and Management Parameters for 10 Mb/s Operation and Associated Power Delivery over a Single Balance

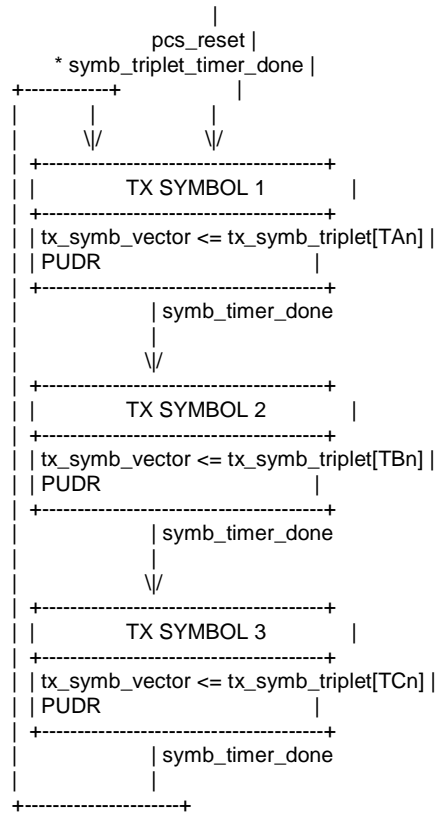
Cl 146 **SC 146.3.3** **P 117** **L 18** # **i-342**
 Law, David Hewlett Packard Enterprise
Comment Type **TR** **Comment Status** **X**
 Is it correct that 'The PCS Transmit function shall conform to the PCS Transmit state diagram in Figure 146-5 ...' and that 'In each symbol period, PCS Transmit generates a symbol An provided to the PMA ...'? The PCS Transmit state diagram in Figure 146-5 changes state based on STD being true, with STD being an alias for symb_triplet_timer_done, and the output of the PCS Transmit state diagram is tx_symb_triplet which is defined in subclause 146.3.3.1.1 'Variables' as 'A triplet of ternary symbols generated by the PCS Transmit function after 4B3T encoding.'

I think the problem is that there is another function within the PCS Transmit function that is missing from the PCS Transmit state diagram in Figure 146-5, the 'multiplexor' shown in Figure 146-6 'PCS transmit symbol generation'. This 'multiplexor' function operates at the symbol clock rate and serialises the tx_symb_triplet code-groups output by the PCS Transmit state diagram into individual symbols.

This may also explain when subclause 146.3.3.1.3 'Timers' defines the symb_timer that is not used in the PCS Transmit state diagram in Figure 146-5.

tx_symb_vector
 A ternary symbol generated through serialization of tx_symb_triplet. This symbol is conveyed to the PMA as the parameter of a PMA_UNITDATA.request(tx_symb_vector) service primitive.
 Values: A ternary transmit symbol. The ternary symbols may take on one of the values {-1, 0, +1}.

tx_symb_triplet(TAn, TBn, TCn)
 A triplet of ternary symbols generated by the PCS Transmit state diagram. The element TAn is the first ternary symbol transmitted; TCn is the last ternary symbol transmitted.
 Value: A triplet of ternary transmit symbols. Each of the ternary symbols may take on one of the values {-1, 0, +1}.

[4] Add a new subclause 146.3.3.2.2 titled 'Timers'. Move the symb_timer definition from subclause 146.3.3.1.3 Timers to this new subclause.

[6] Insert a new Figure 145-6 shown below (view using a non-proportional font such as courier), renumbering the following figures as required.

[7] Add text to subclause 146.3.3 'PCS Transmit' that reads 'The PCS Transmit function shall conform to the PCS Transmit state diagram in in Figure 146-5 and the PCS Transmit multiplexor state diagram in 146-6, and their associated state variables, functions, timers, and messages.'
